PICKLEBALL COURTS, RESTROOMS, ROADWAY AND PARKING LOT IMPROVEMENTS

INVITATION TO BID – REQUISITION NO. 2025-0313

ADDENDUM NO. ONE (1) – DATED FEBRUARY 17, 2025

Cabana Bench 10' - Cabana Bench 10' & Modified Cabana Bench 10' | Sun Trends Inc.

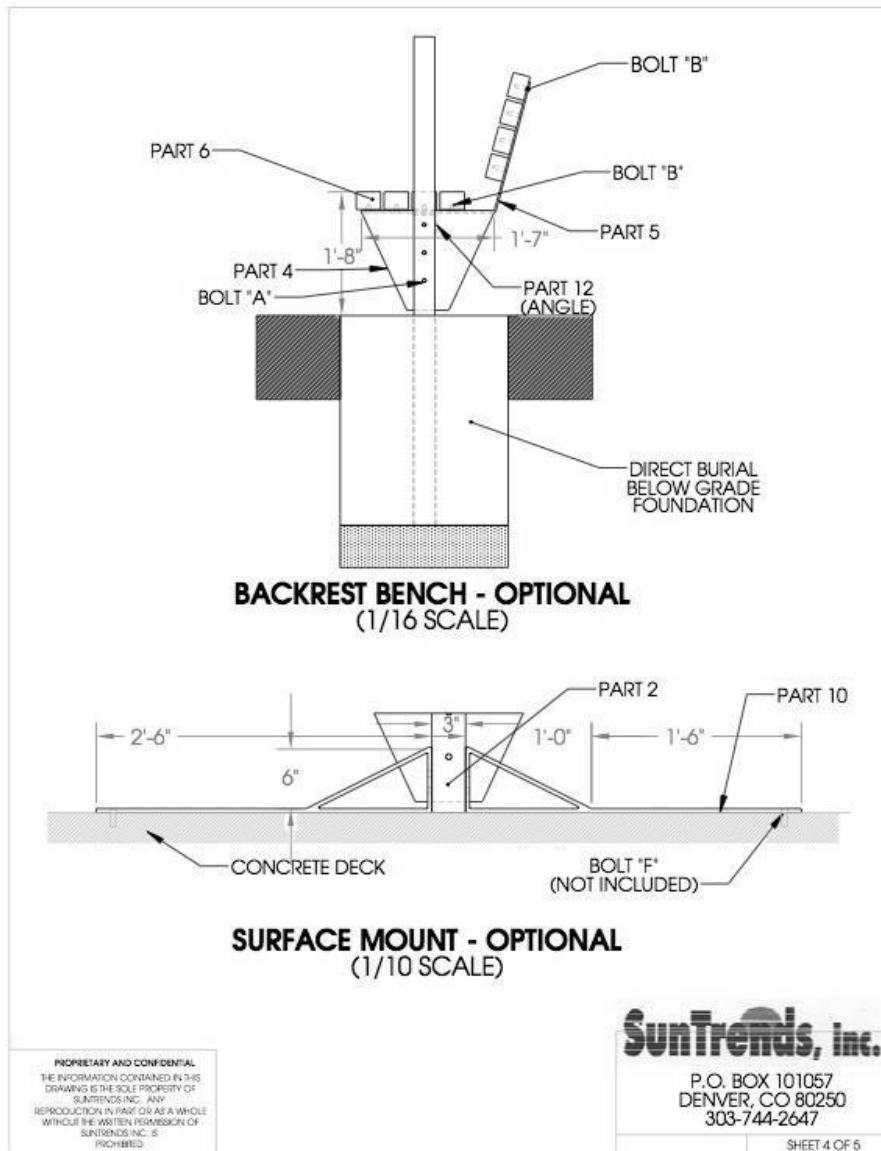
- 1. Can a spec sheet be provided for the 10 ft cabanas that are detailed on Sheet 4.001-19?*

- 2 sided flat bench
- Direct bury foundation with sleeve
- Custom canopy color

10' Long, 6' Wide, 8'10" High

Steel Post Size: 3" x 3"

Weight: 520 LBS

Flat bench: 8' long by 36" wide

3" x 4" Slats, Durawood Plastic Composite Material
